Deadline 9 submissions to Planning Inspectorate, National Infrastructure Planning: Ref. TR010025

Prepared by Dr. G.M. Reeves for the **Stonehenge Alliance. Ref.2001870**

PART ONE: Summary response to Highways England's Deadlines 7 and 8 submissions REP7-081 and REP8-013 on matters relating to Flood risk, groundwater protection, geology and land contamination.

PART TWO: Response to Highways England's Deadline 8 Submission REP8-018: Written Summary of oral submissions put at Flood Risk, groundwater protection, geology and land contamination hearing on 29 August 2019, Appendix A - Highways England Comments on Dr GM Reeves Presentation.

Figure 2: from AWM Report No. TR010025 Document 8.23 – Implications of 2018 Ground Investigations to the Groundwater Risk Assessment (republished with tracked changes, dated 31.05.19) - Travis et al.

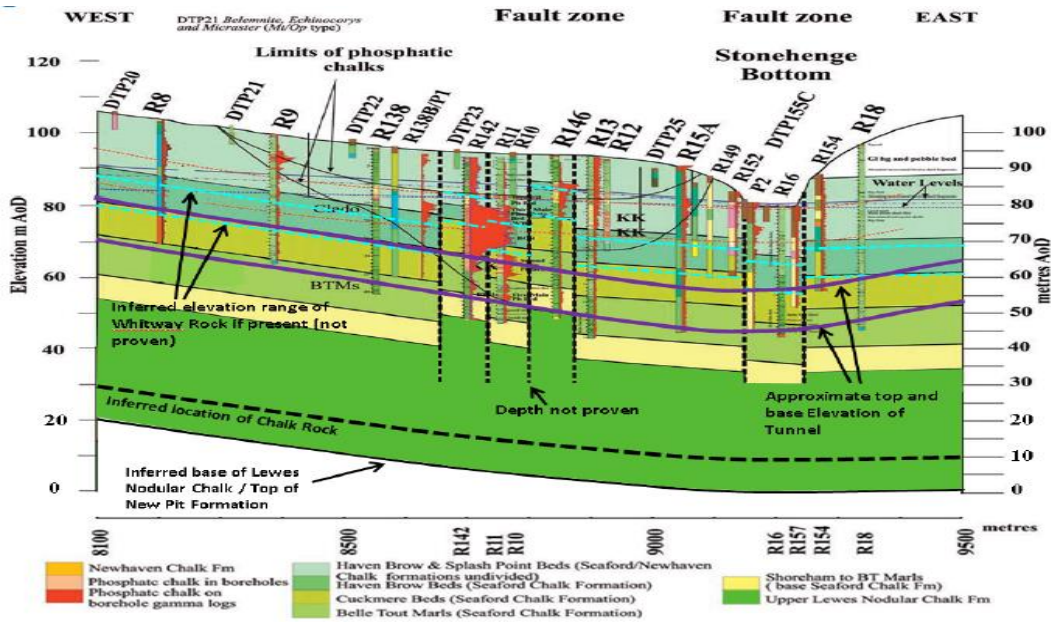
2.5.1. As mentioned in our ISH 10 summary of oral submissions, in examining the detail of groundwater and lithological data relating to the Whitway Rock horizon, it was noticed that Highways England had used a dated (2012) figure, attributed to Professor Rory Mortimore in his 2012 Glossop Lecture publication (for ease of reference, please see reproduction below). It remains uncertain if the AWM groundwater modellers have superimposed the profile of the proposed tunnel (as defined in the HEng A303 Amesbury to Berwick Down, Project Documents: 2.7 Engineering Section Drawings (Plan and Profiles documents) onto their Figure 2.

2.5.2. The groundwater levels and postulated zone range of the Whitway Rock horizon are also problematic (see figure below, as used in Stonehenge Alliance’s presentation to ISH 10).

2.5.3. There is no obvious reason, nor any explanation why the Mortimore 2012 version of the proposed A303 tunnel route section is used and represented in AWM Report No. TR010025 Document 8.23 – Implications of 2018 Ground Investigations to the Groundwater Risk Assessment (republished with tracked changes, dated 31.05.19) by Travis et al. Why was Mortimore’s 2012 figure used in preference to the presumably up-dated figure (16a) in Mortimore et al., 2017? (shown below for ease of reference)
